WHITE'S LAKE DAM
STODDARD COUNTY, MISSOURI

MISSOURI INVENTORY NO. 40034

PHASE I INSPECTION REPORT
NATIONAL DAM SAFETY PROGRAM

MARCH 1980

Photo 11: Inlet Structure

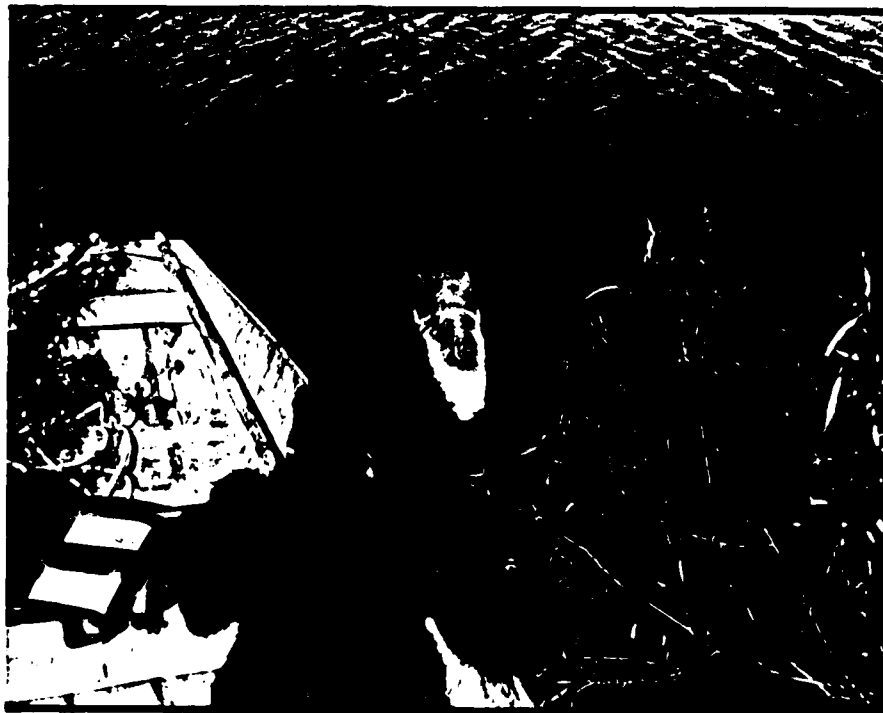
c. Appurtenant Structure. A canopy inlet structure constructed of 8 inch diameter steel pipe that runs on a slope of 1V on 5.7H through the embankment for a horizontal distance of 122 feet is the primary means of discharge (see Photo 11). The inlet invert elevation is 420.8 N.G.V.D. No trash rack was observed. The outlet invert elevation is 399.4 N.G.V.D. The outlet discharges into a stilling basin whose approximate dimensions are 15' x 10' and which is approximately 5 feet deep (see Photo 12). The inlet and discharge pipe appear to be in relatively good condition. The stilling basin appears to be stable.
